**SERVICE BULLETIN**

**APPLICABILITY:** 2015 Legacy and Outback Models

**NUMBER:** 10-81-14

**SUBJECT:** Whistling Sound from Rear Seat Console Air Vents

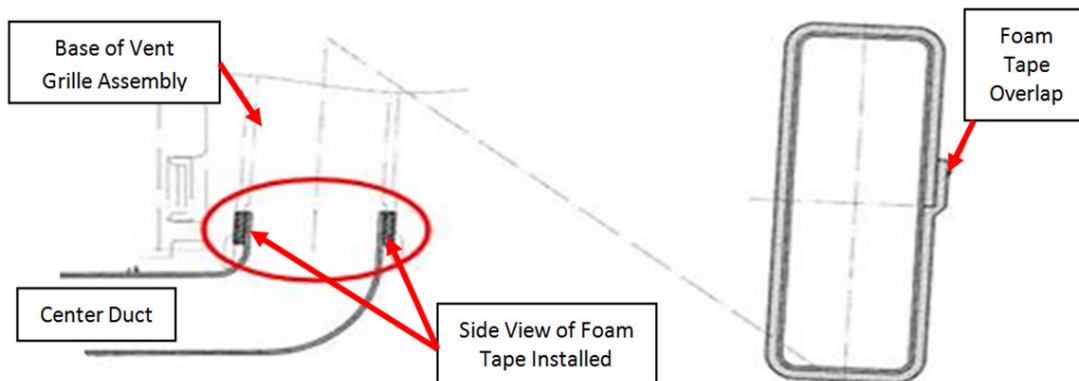
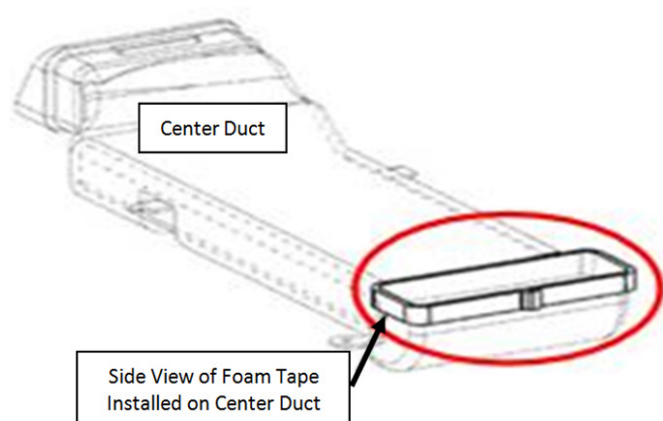
- Identify the area of the center duct which fits inside the base of the vent grille assembly as shown in the photo and illustration below.

- Trial fit the foam tape making sure it wraps completely around the top edge of the center duct and overlaps by about ½ inch at the ends **on the back edge** as shown above.
- Clean the area where the foam tape will be applied with a mild solvent on a clean shop cloth. After drying, peel the adhesive backing and apply the foam tape flush with the top edge of the center duct as shown below. **IMPORTANT:** The overlap **must** be in the position shown below.
